## Transmittal

**ATTN:** Greg Scott  
**DATE:** 05/22/12  
**PROJECT:** Munjoy Hill PFD - Monopole  
**PROJECT No:** 2612

Copies	Date	Description
1	05/17/12	Submittal No. 003A - Reinforcing Steel Dwg. No. R01

SHEARWALL WALL #2

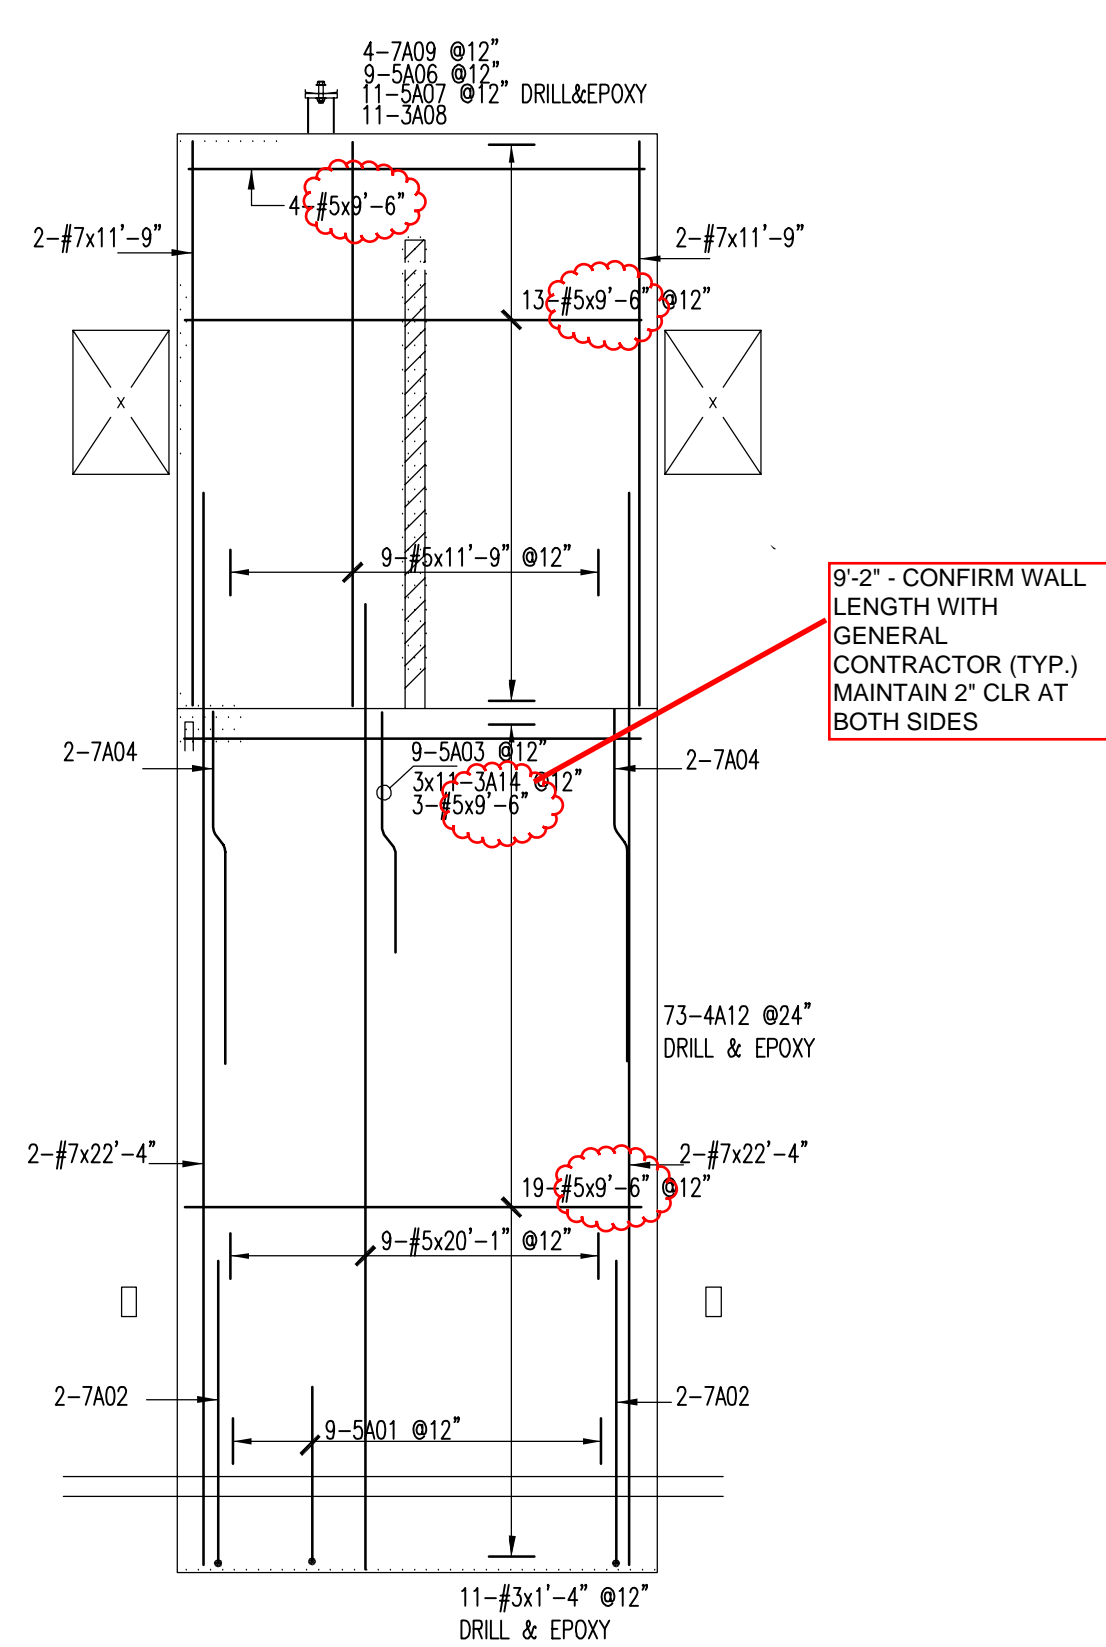
**Comments:**  
 Please coordinate proposed length of shotcrete wall no. 2 with Barker Steel. See attached sketch depicting our understanding of the revised wall length to avoid interference with control joint at shotcrete wall no. 2. If this differs from field measured locations of the control joint please contact us before proceeding with the requested modification. Thanks.

SHOTCRETE WALL NO. 2

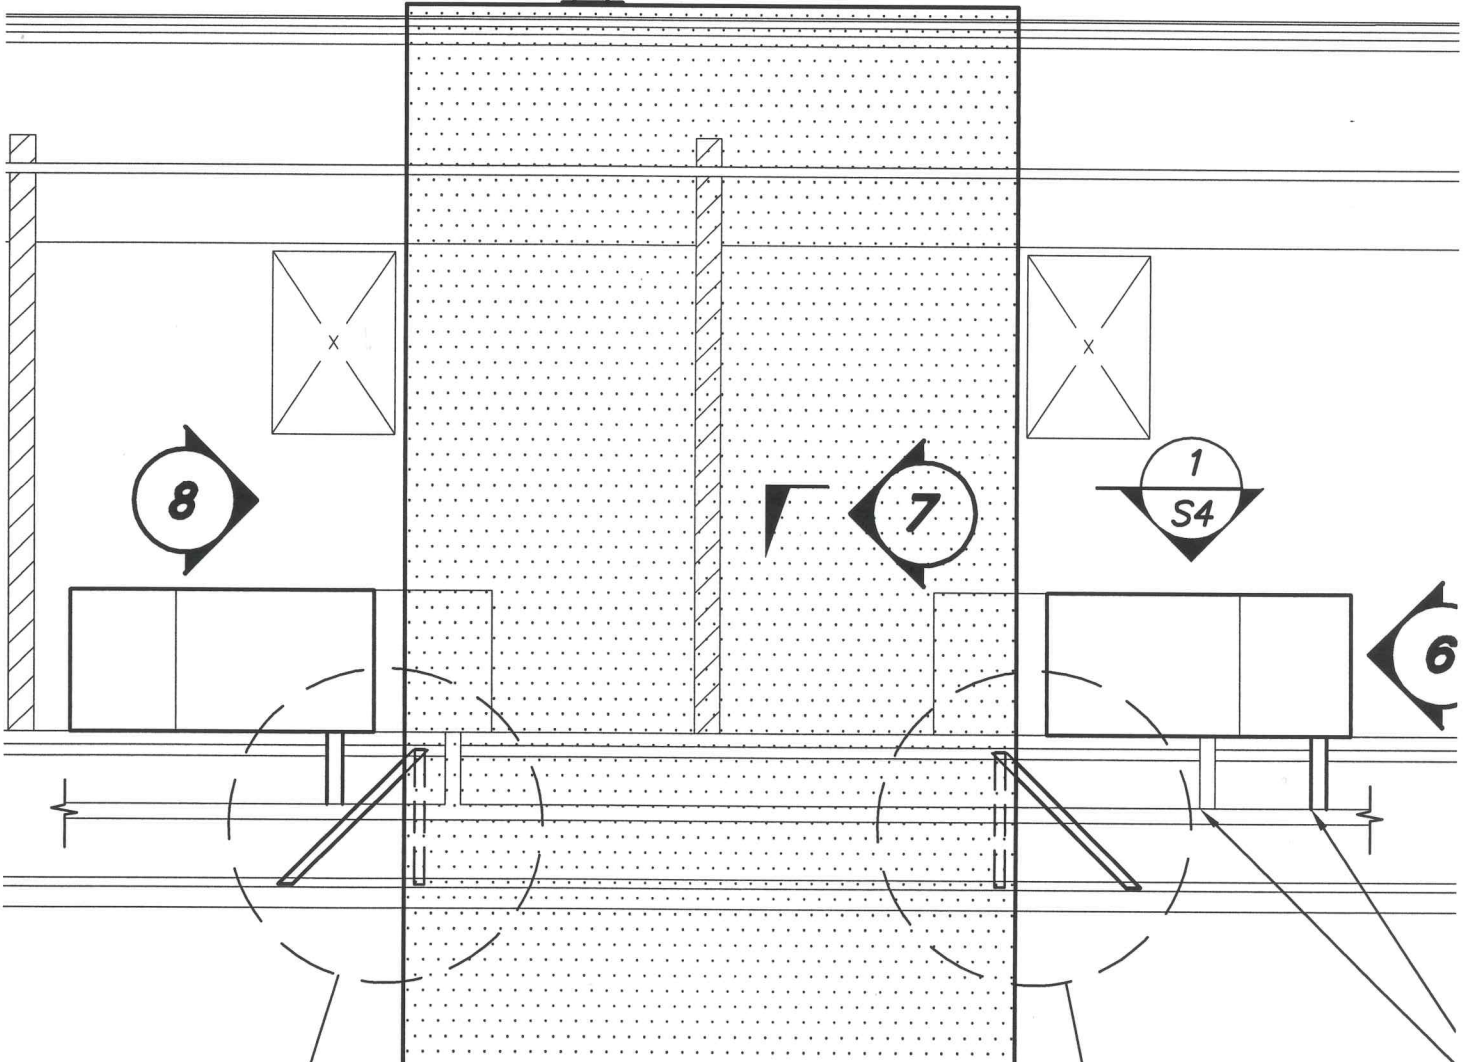
△ PROPOSED MODIFICATION TO SHOTCRETE WALL NO. 2 TO AVOID INTERFERENCE WITH EXISTING CONTROL JOINT
